Clinch River Nuclear Site
NRC Docket No. 52-047

Subject: Submittal of Supplemental Information Related to the Exclusion Area Boundary and Population Distribution Around the Clinch River Nuclear Site in Support of the Early Site Permit Application

Supplemental Information Regarding the Exclusion Area Boundary and Population
Distribution Around the Clinch River Nuclear Site

Figure 2.7.6-2. LPZ and analytical EAB distances used for the Complex Terrain Analysis

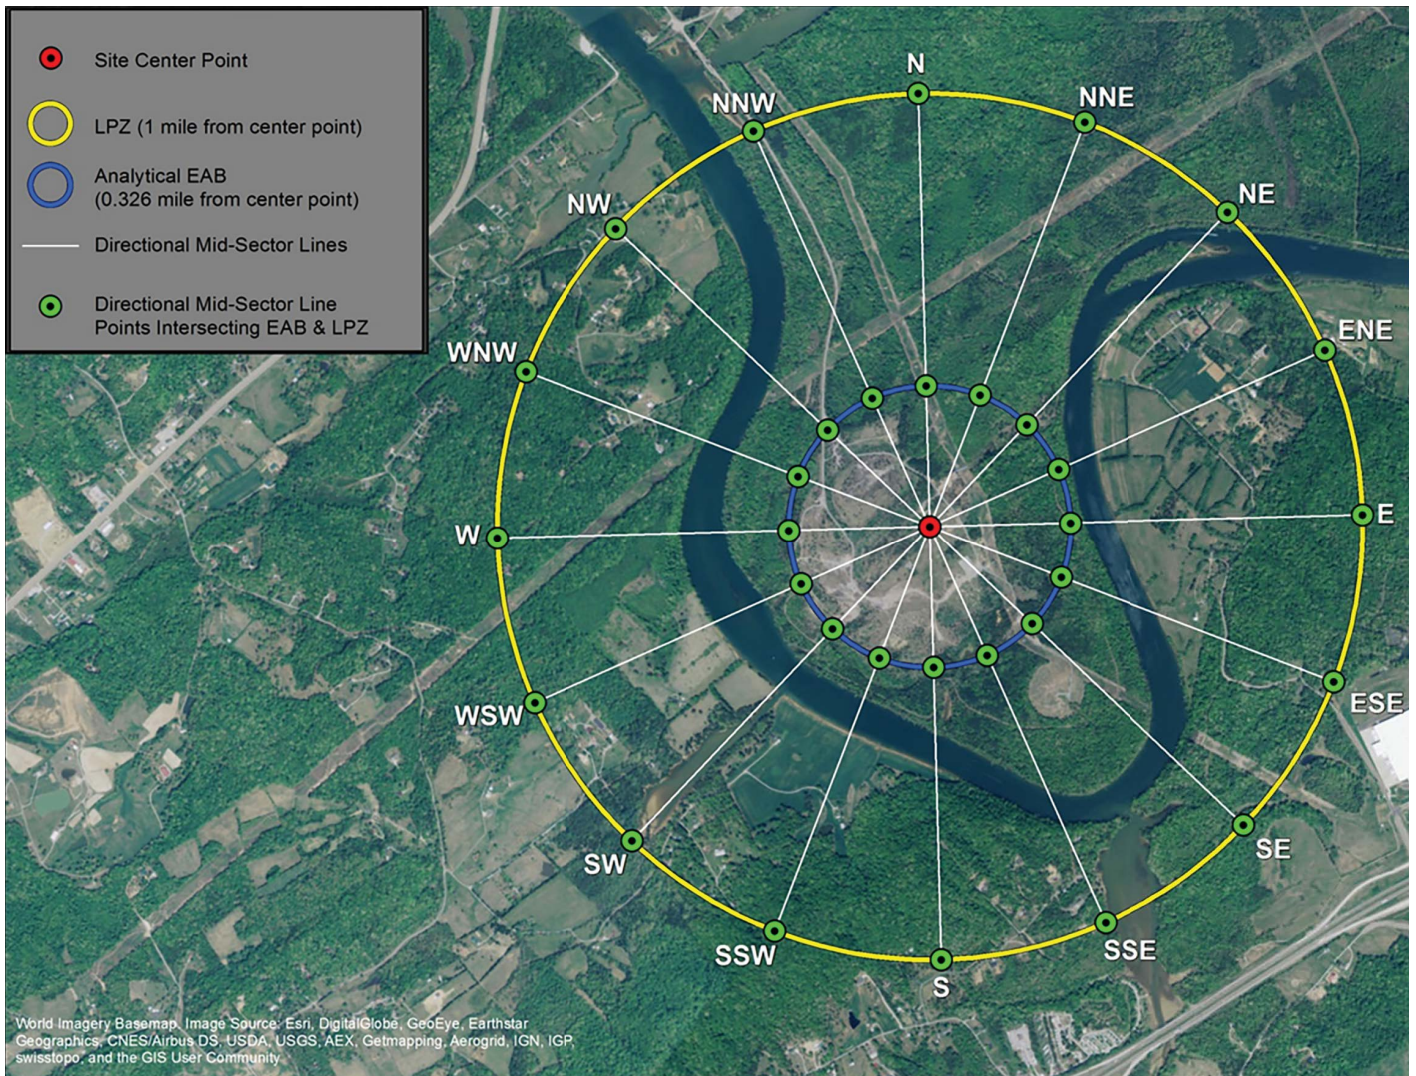
ER Figure 2.7.6-2 is being replaced with the figure below.
